## **MAGGIE B. SUBDIVISION**

APPLICATION NUMBER 12 DATE July 24, 2008

REQUEST Subdivision

# DETAIL SITE PLAN

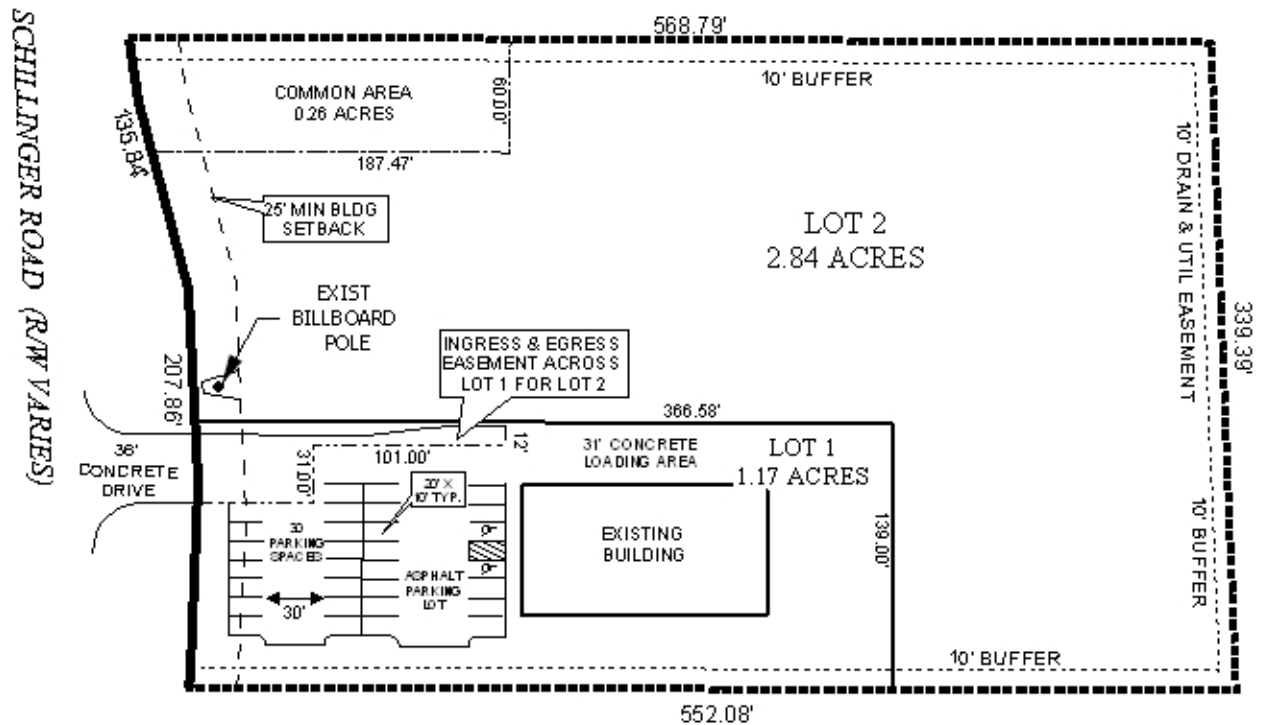
The 25-foot minimum building setback line is indicated on the plat and should also be illustrated on the final plat. Each lot is labeled with its size in acreage, and these should also be labeled on the final plat, or a table should be furnished providing the same information.

A common area is indicated in the Northwest corner of proposed Lot 2 fronting onto Schillinger Road South. A note should be placed on the final plat stating that the common area is denied access to Schillinger Road South, and a note should be placed on the final plat stating that the maintenance of the common area is the responsibility of the property owners.

- 1) placement of a note on the final plat stating that each lot is limited to one curb cut to Schillinger Road South, with the size, location and design to be approved by County Engineering and conform to AASHTO standards;

- 2) illustration of the 25' minimum building setback line along Schillinger Road South;
- 3) labeling of each lot with its size in acreage, or the furnishing of a table on the final plat providing the same information;

- 4) placement of a note on the final plat stating that the common area is denied access to Schillinger Road South;
- 5) placement of a note on the final plat stating that the maintenance of the common area is the responsibility of the property owners;
